# Access Compliance Report

## Public Rights-of-Way

### (Curb Ramps)

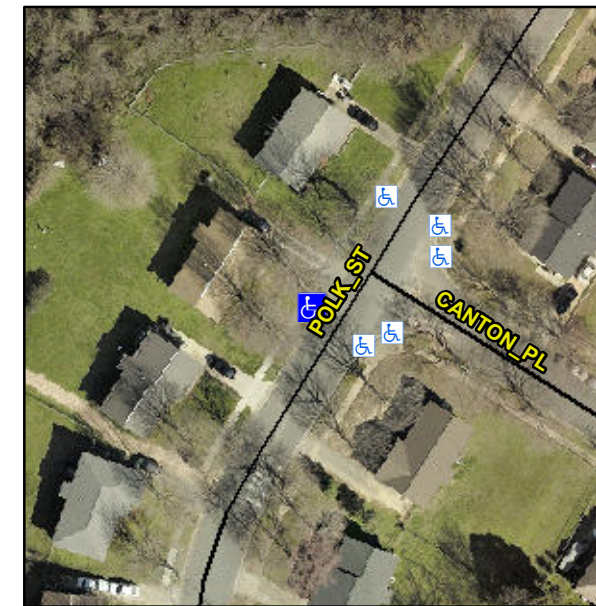
Intersection ID: 10541	Main Street: CANTON_PL	Cross Street: POLK_ST	Location: W
ADA ID: DD8DAE55EA73	Ramp Type: Perp	Initial Pass/Fail: Fail	Overall Compliance: No
Severity Score: 33.75			
Codes/Mitigation Info/Possible Solution		Field Measurements/Component Compliance

**Not Found, R304.5.1, R304.2.2, R304.5.3**

Compliance	Description	Data	Compliance	Description	Data
N/A	Ramp Length (in)	63.5	No	Ramp Slope (%)	8.9
No	Ramp Width (in)	47.0	No	Ramp XSlope (%)	6.9
N/A	Flare Type LT	N/A	N/A	Flare Type RT	N/A
N/A	Flare Slope LT (%)	N/A	N/A	Flare Slope RT (%)	N/A
N/A	Flare Traversable LT?	N/A	N/A	Flare Traversable RT?	N/A
N/A	Landing Length (in)	N/A	N/A	DWS Provided?	N/A
N/A	Landing Width (in)	N/A	N/A	DWS Contrast?	N/A
N/A	Landing Slope (%)	N/A	N/A	DWS Length (in)	N/A
N/A	Landing X Slope (%)	N/A	N/A	DWS Full Width?	N/A
N/A	Landing Curb? (Y/N)	N/A	N/A	DWS Offset (in)	N/A
N/A	Shared Landing?	N/A			
N/A	Gutter Ponding?	N/A	N/A	Gutter Slope (%)	N/A
N/A	Gutter Lip Ht (in)	0.5	N/A	Gutter X Slope (%)	N/A
N/A	Painted X Walk1?	No	N/A	Painted X Walk2?	N/A
	X Walk 1 Direction	To SE		X Walk 2 Direction	N/A
N/A	X Walk 1 Width (in)	N/A	N/A	X Walk 2 Width (in)	N/A
	X Walk 1 Slope (%)	3.0		X Walk 2 Slope (%)	N/A
	X Walk 1 X Slope (%)	4.9		X Walk 2 X Slope (%)	N/A

**Remove & Replace Entire Ramp.**
